**REPORT ON PLANT  
FOR BAYSHORE, BEAR GULCH, CHICO, REDWOOD  
VALLEY, & STOCKTON DISTRICTS**

**California Water Service Company  
Test Year 2017 General Rate Case  
A.15-07-015**

**San Francisco, California  
March 2016**

Figure 2-A: 2005-2014 Recorded MDD– San Carlos Service Area

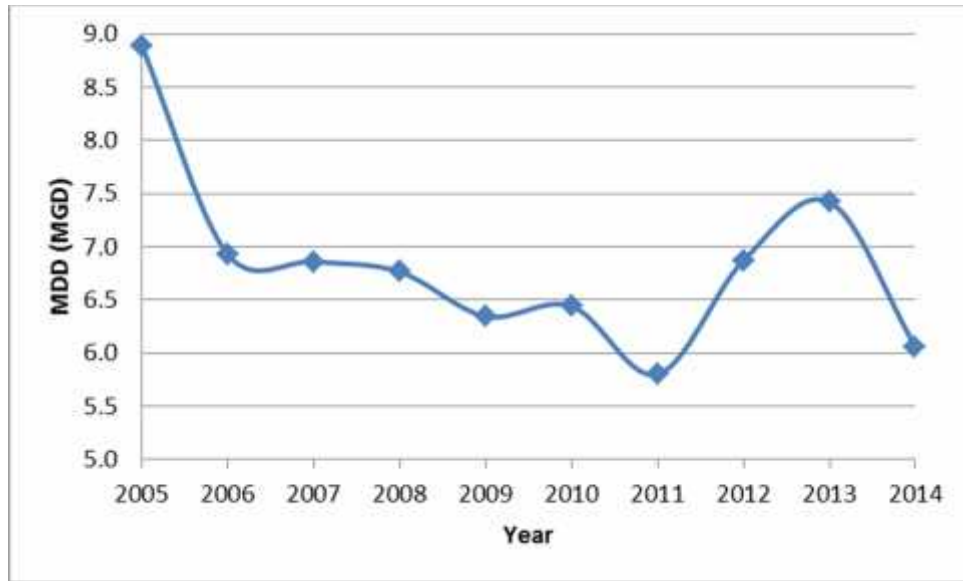
It is more appropriate to use demand data from more recent years (2010-2014). Over the past five years, the maximum MDD occurred in 2013 with a MDD of 7.421 MGD.<sup>53</sup> The MDD was allocated throughout the different pressure zones in the system proportionally based on the percentage of pressure zone demand in comparison to the overall demand of the entire San Carlos service area.<sup>54</sup> Based on CWS's methodology, the MDD required would be \*\*\*BEGIN CONFIDENTIAL\*\*\*

**Figure 2-B: 2005-2014 Recorded MDD– San Mateo Service Area**

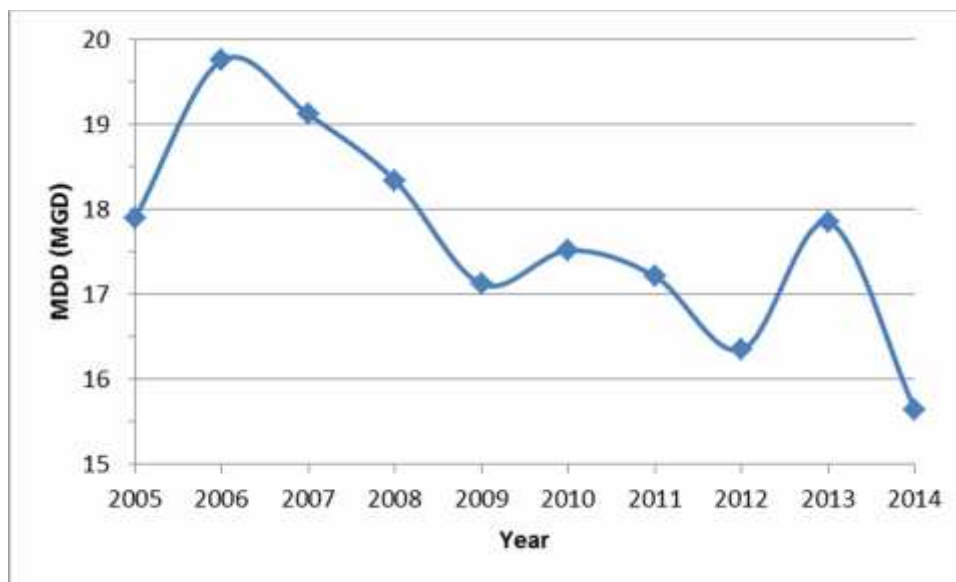
It is more appropriate to use demand data from more recent years (2010-2014). Over the past five years, the maximum MDD occurred in 2013 with a MDD of 17.84 MGD.<sup>79</sup> The MDD was allocated throughout the different pressure zones in the system proportionally based on the percentage of pressure zone demand in comparison to the overall demand of the entire San Mateo service area.<sup>80</sup> The six pressure zones, which will be served by the proposed tank comprise of 85.9% of the San Mateo system demand.<sup>81</sup> After

**Figure 3-A: 2005-2014 Recorded MDD– Bear Gulch District**

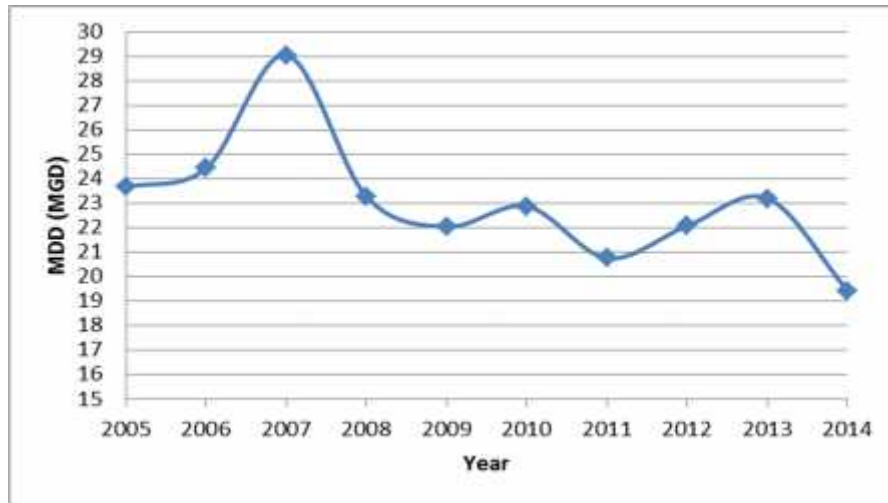
It is more appropriate to use demand data from more recent years (2010-2014). Over the past five years, the maximum MDD occurred in 2013 with a MDD of 23.19 MGD.<sup>127</sup> The MDD was allocated throughout the different pressure zones in the system proportionally based on the percentage of pressure zone demand in comparison to the overall demand of the entire district.<sup>128</sup> The seven pressure zones, which will be served by the proposed tank comprise of 70% of the BG system demand.<sup>129</sup> After incorporating the 2013 demand data, the total supply of 33.12 MGD from the seven pressure zones
